UNITED STATES ENVIRONMENTAL PROTECTION AGENCY
WASHINGTON, D.C. 20460

This letter provides the results of the U.S. Environmental Protection Agency's (EPA) unannounced continued compliance inspection at the Advanced Mixed Waste Treatment Project (AMWTP) facility in Idaho Falls, ID. On November 17-18, 2010, EPA inspected AMWTP's waste characterization (WC) program for contact-handled (CH) transuranic (TRU) waste. As a result of this unannounced continued compliance inspection, EPA confirmed that AMWTP continues to characterize CH TRU waste consistent with the conditions and limitations from EPA's baseline approval granted in October 2006 (EPA Air Docket No. A-98-49; II-A4-66). The enclosed report (EPA Air Docket No. A-98-49; II-A4-143) gives the details of the evaluation.

WASTE CHARACTERIZATION INSPECTION REPORT
EPA UNANNOUNCED CONTINUED COMPLIANCE INSPECTION
NO. EPA-AMWTP-CH-UA-10.10.24 OF THE CONTACT-HANDLED
WASTE CHARACTERIZATION PROGRAM
AT THE ADVANCED MIXED WASTE TREATMENT PROJECT

November 17-18, 2010

Figure 1. Hanford Drum Process Flow through the Advanced Mixed Waste Treatment Project

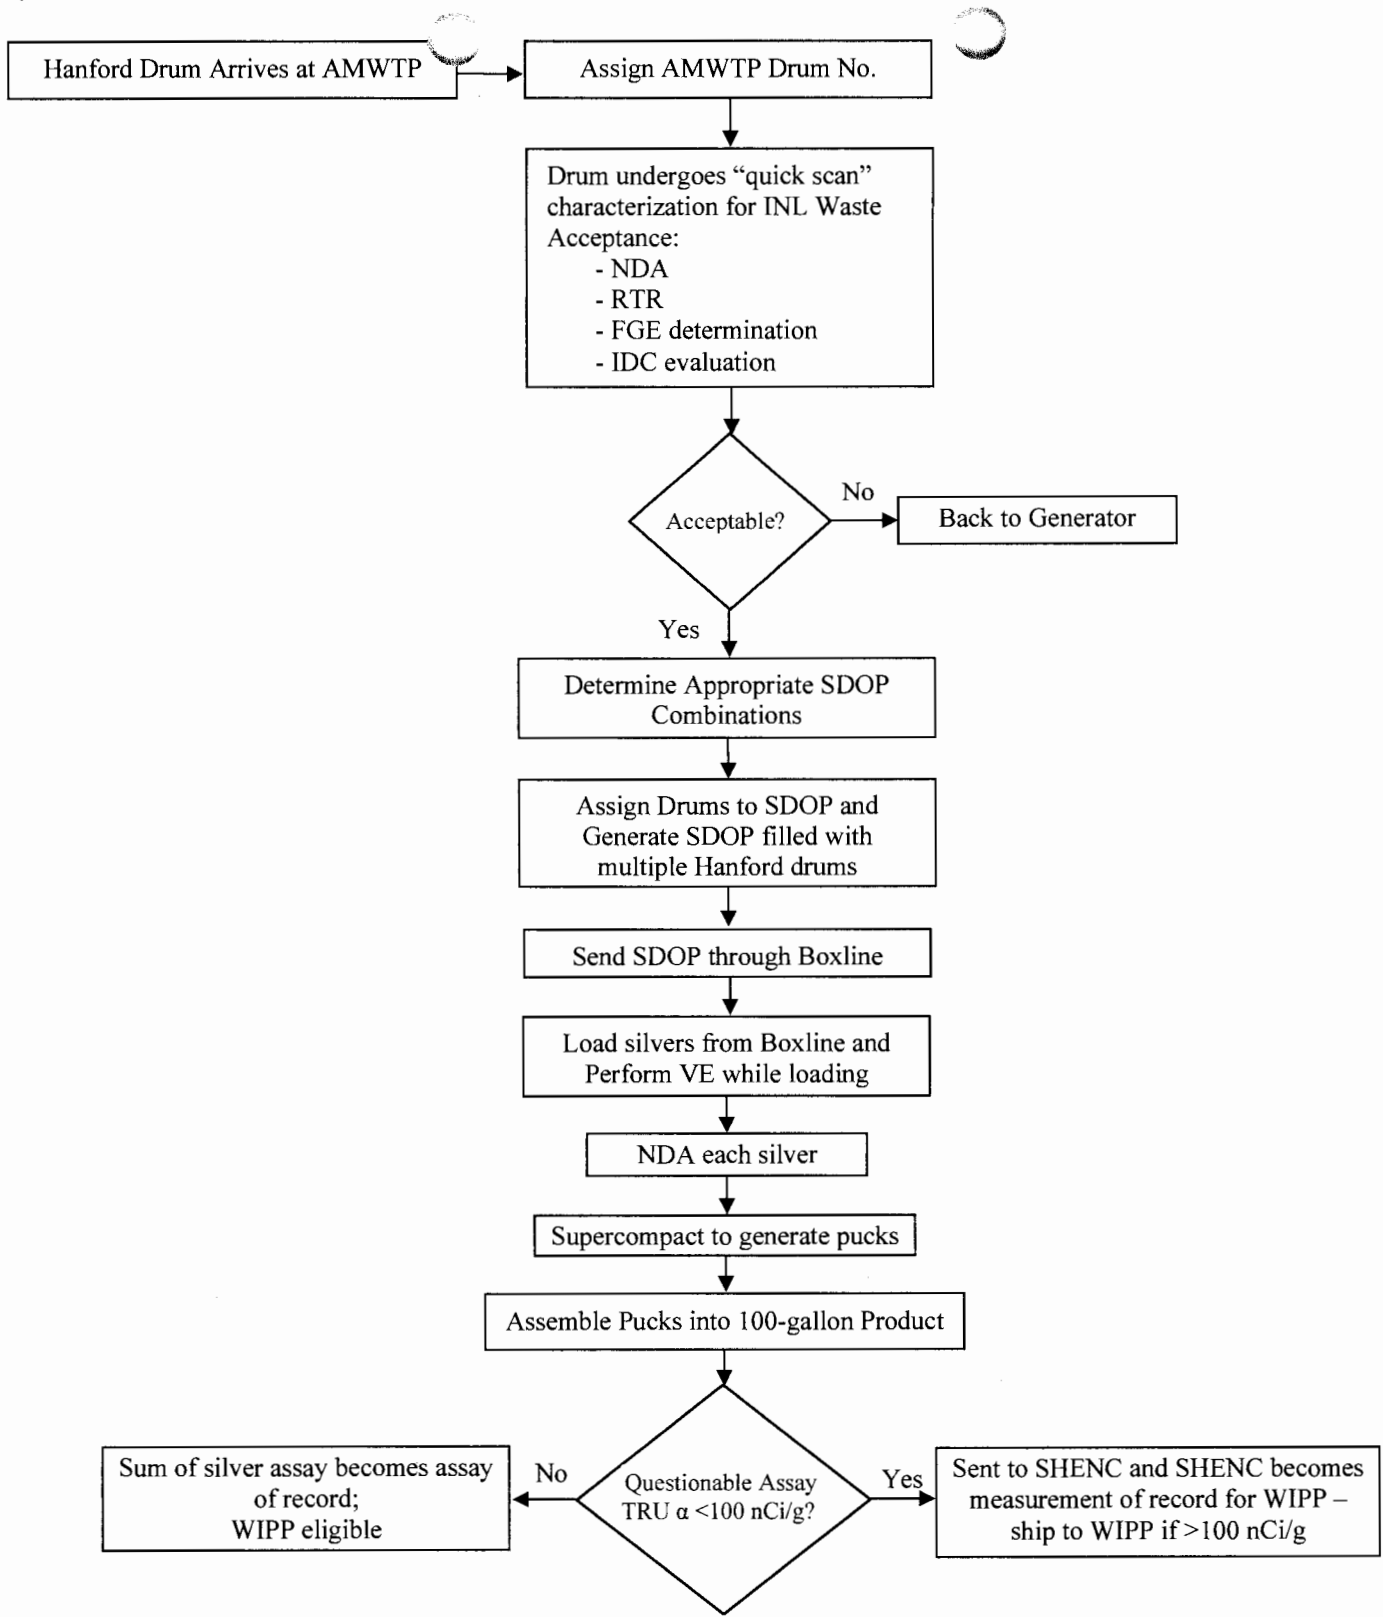
- (3) Data tracking and data traceability of Hanford waste in the Advanced Mixed Waste Treatment Project system, including traceability of batch data reports, was examined and found to be adequate.

AMWTP uses the AMWTP Waste Tracking System (WTS) to track information pertaining to incoming drums from offsite sources, including the Hanford drums. Figure 1 presents the data flow and characterization process associated with Hanford drums. As shown in this chart, drums from Hanford arrive and are assigned an AMWTP drum number; drums then undergo screening

NDA and RTR (i.e., “fast scan”) to evaluate their acceptability according to the INL waste acceptance criteria. If a drum is acceptable, it is combined with others into a six-drum overpack (SDOP). The SDOP is then shredded, and the shredded SDOP is loaded into 55-gallon drums called “silvers.” VE is performed on a “silver” at the time of drum loading and is followed by NDA, after which it is supercompacted or “pucked.”³ The pucks are placed in a 100-gallon drum which may be sent to the INL-CCP Super High Efficiency Neutron Counter (SHENC) for additional assay if data suggest the drum’s TRU alpha activity may be less than 100 nanocuries per gram (nCi/g). Table 3 presents examples of drums sent from Hanford as they went through the AMWTP process described above (the table progresses from left to right). The table does not include all of the “silvers” generated from the specified SDOP, but includes examples to demonstrate traceability of the process. Table 3 and Figure 1 indicate that data are traceable from the original Hanford drums through the final 100-gallon product drum. Per agreements with the State of Idaho, any drum from Hanford must undergo characterization within six months of receipt at AMWTP, and must be removed from Idaho within six months of characterization. The first Hanford drums arrived at AMWTP in September 2010.
